Access Compliance Report

Public Rights-of-Way

Intersection ID: 3847	Main Street: HIGHSTREAM_CT	Cross Street: POPLAR_GROVE_DR	Location: NW
ADA ID: 1BB9A51D1314	Ramp Type: Perp	Initial Pass/Fail: Fail	Overall Compliance: No
			Severity Score: 21.25

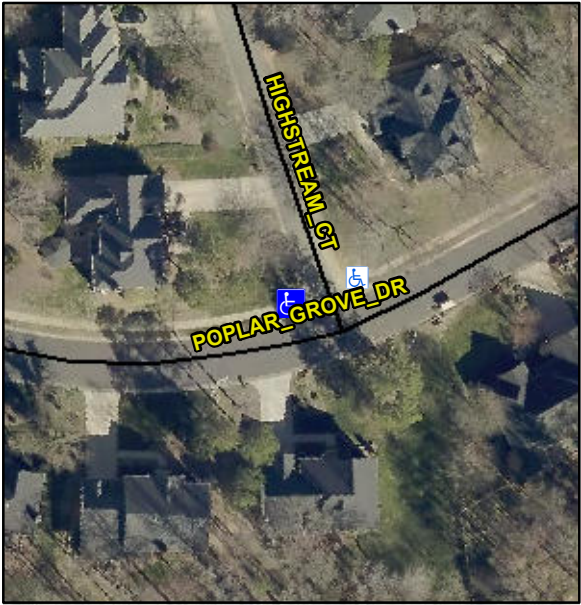
Codes/Mitigation Info/Possible Solution			Field Measurements/Component Compliance		
	Possible Solutions:		Compliance	Description	Data
	Remove & Replace Entire Ramp.		No	Ramp Length (in)	41.0
			No	Ramp Width (in)	47.0
			N/A	Flare Type LT	N/A
			N/A	Flare Slope LT (%)	N/A
			N/A	Flare Traversable LT?	N/A
			N/A	Landing Length (in)	N/A
			N/A	Landing Width (in)	N/A
			N/A	Landing Slope (%)	N/A
			N/A	Landing X Slope (%)	N/A
<p>Surveyor Notes:</p> <p>N/A</p> <p>PROW/ADA:</p> <p>Not Found, R304.5.1, R304.2.2</p>			N/A	Flare Type RT	N/A
			N/A	Flare Slope RT (%)	N/A
			N/A	Flare Traversable RT?	N/A
			N/A	DWS Provided?	N/A
			N/A	DWS Contrast?	N/A
			N/A	DWS Length (in)	N/A
			N/A	DWS Full Width?	N/A
			N/A	DWS Offset (in)	N/A
			N/A	Gutter Ponding?	N/A
			N/A	Gutter Lip Ht (in)	N/A
			No	Painted X Walk1?	N/A
				X Walk 1 Direction	To E
			N/A	X Walk 1 Width (in)	N/A
				X Walk 1 Slope (%)	2.2
				X Walk 1 X Slope (%)	1.2
